Children's Program Room:

Multi-Purpose Room:

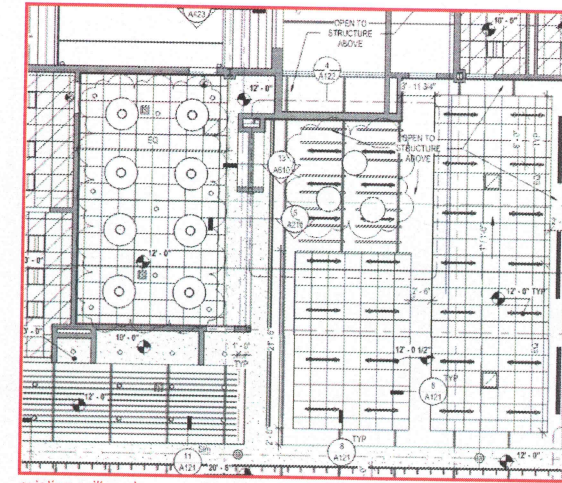
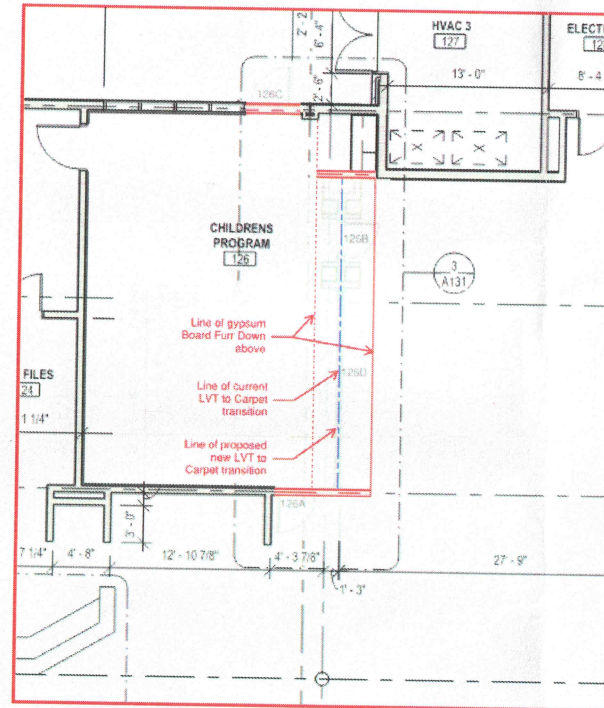
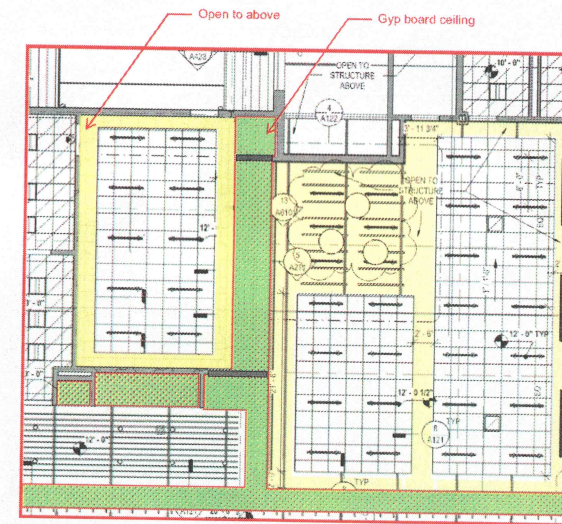
- Remove Doors 126A, 126B, 126C & 126D
- Remove wall and built in shelving associated with doors 126D & 126B
- Fill in door 126A and extend wall to align with edge of gypsum board ceiling.
- Adjust LVT and Carpet line to align with edge of Gypsum Board ceiling.
- Ceiling revisions in Children's Room to pull Suspended Ceiling away from walls and paint exposed structure above to better match adjacent ceiling design.
- Change round light fixtures to linear light fixtures to match adjacent spaces. Count will change from 8 to 10.

Option 1:

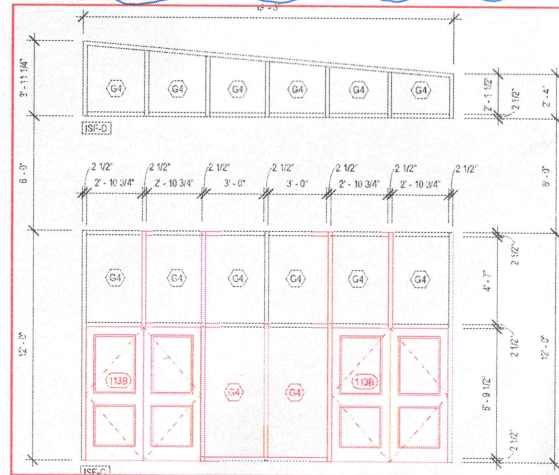
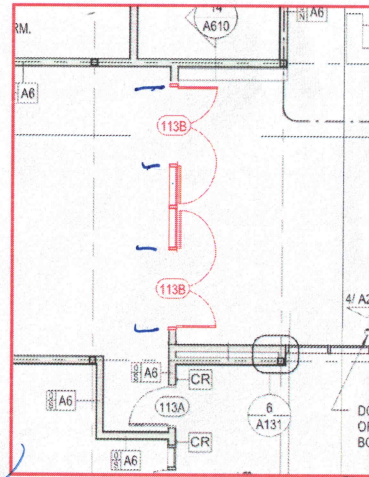
- Replace existing (1) dbl door with (2) dbl doors.

Option 2:

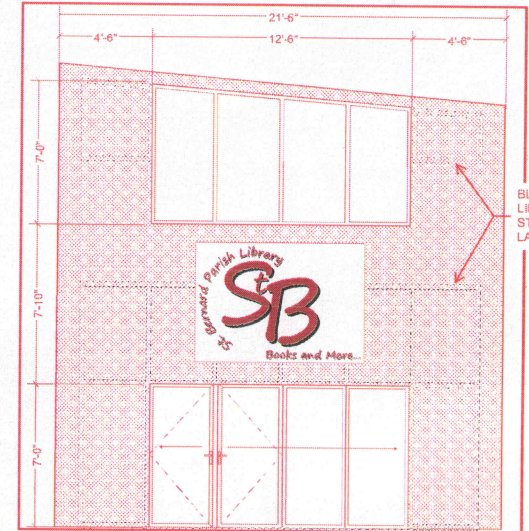
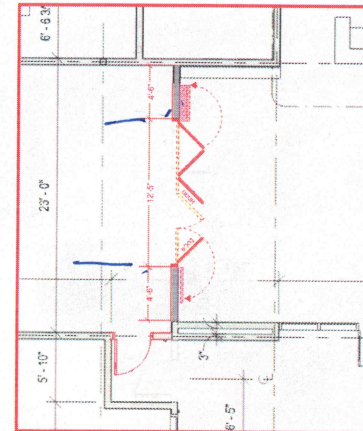
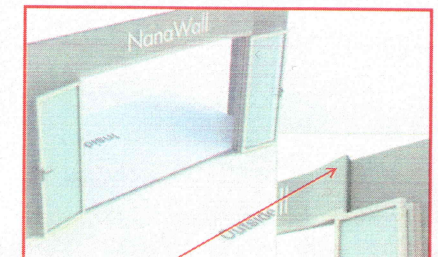
- Remove existing 19" x 12' interior storefront system. (6 bays - one 6' wide dbl door)
- Replace with 12'-6" x 7" "Fold Flat" Nana Wall. (4 bays two 3' wide swing doors)
- Remove existing upper 19" x 4' storefront windows
- Replace with 12'-6" x 7' storefront window
- Nana Wall will require:
 - Furr-out at head of wall to house top track.
 - Additional metal framing will be required at head and jambs
- Consider adding graphic between door and clerestory windows.
- Revise Lobby entrance to swing door out for egress.

BLACK DASHED LINE IS CURRENT STOREFRONT LAYOUT

Base track will be recessed in slab.

Note furr-out to accommodate top track.
